**LAKEHAVEN WATER AND SEWER DISTRICT**

**2025 LAKOTA MISCELLANEOUS IMPROVEMENTS PHASE 2**

**Bid Number: 25-1684**

**ADDENDUM NO. 2**

**B PC-203 SECTION**  
3/16"=1'-0"  
M-02  
M-03

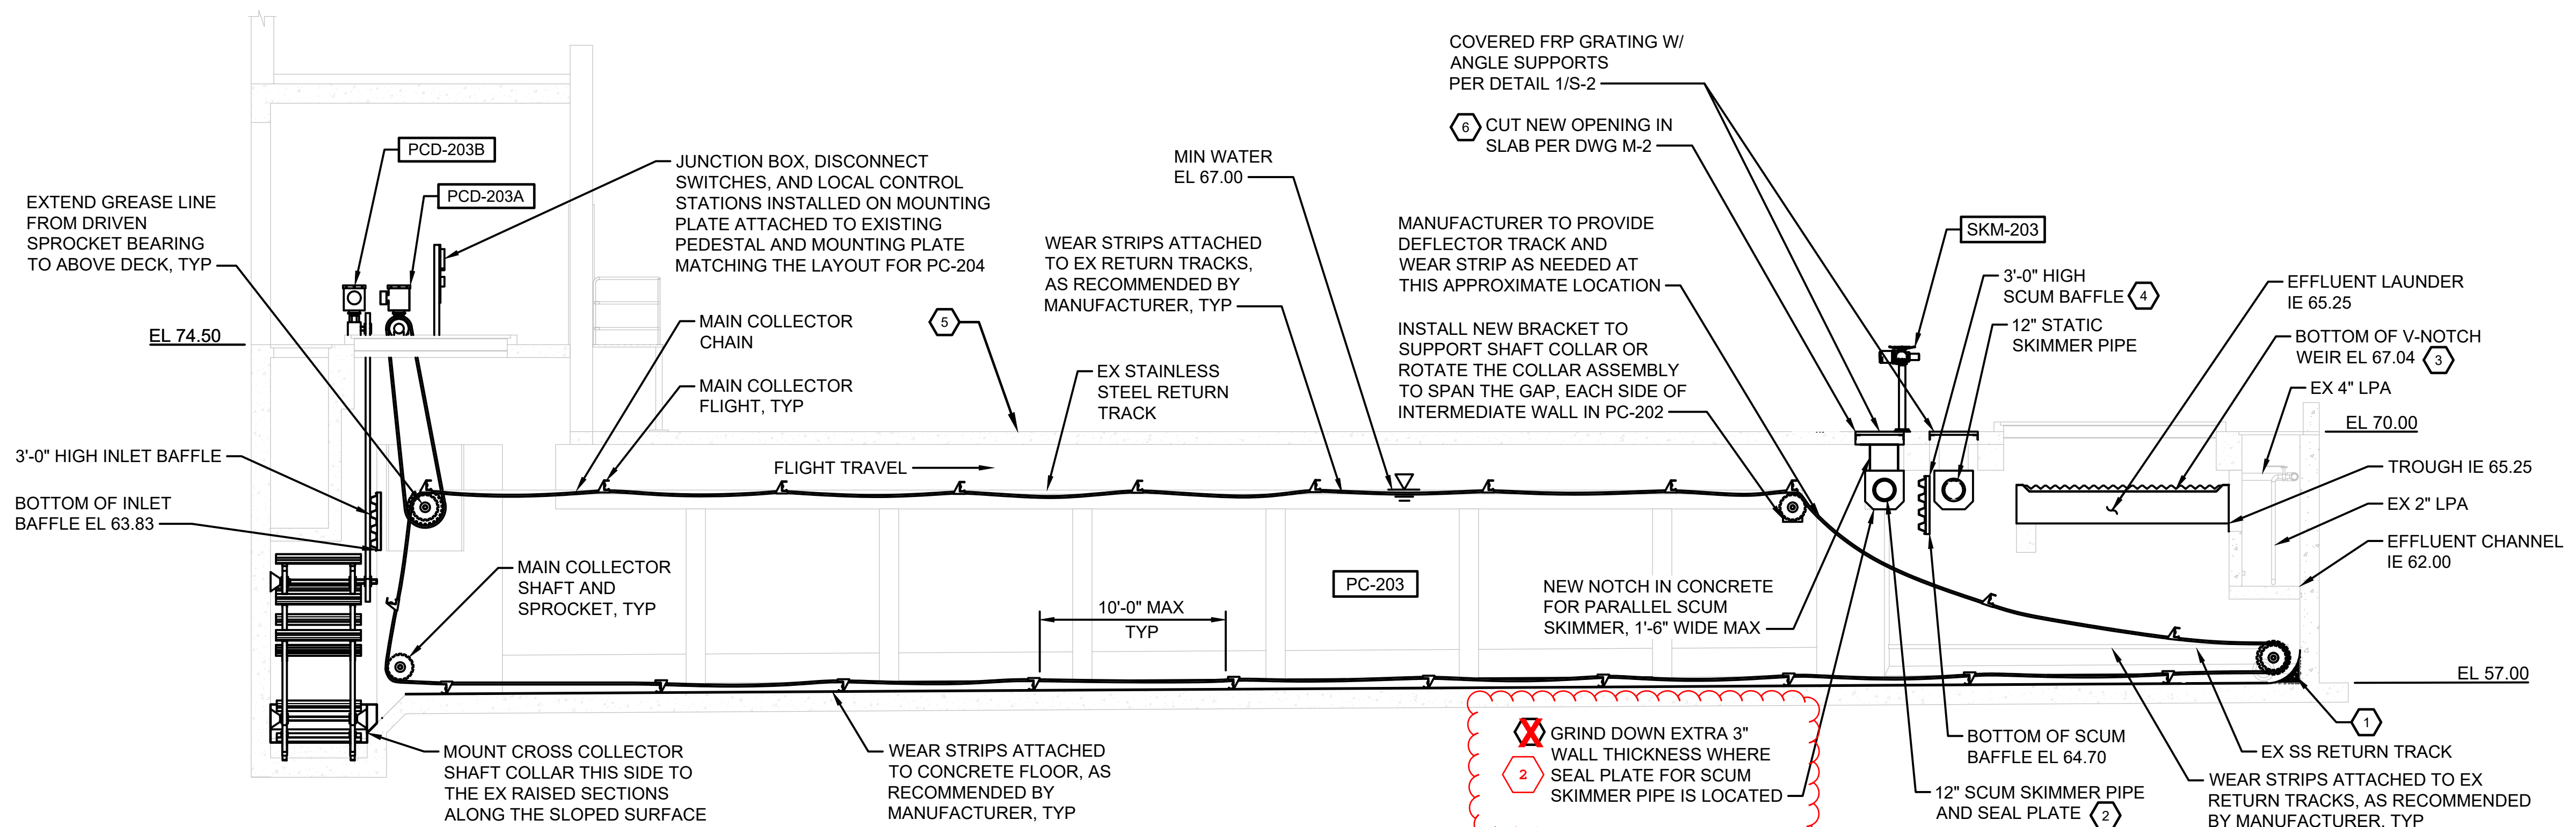
Sheet M-04 shall be replaced in its entirety with the revised Sheet M-04 attached hereto. This drawing clarifies that Keynote 3 shown in the Detail B plan view labeled "GRIND DOWN EXTRA 3" WALL THICKNESS WHERE SEAL PLATE FOR SCUM SKIMMER PIPE IS LOCATED" should be Keynote 2.
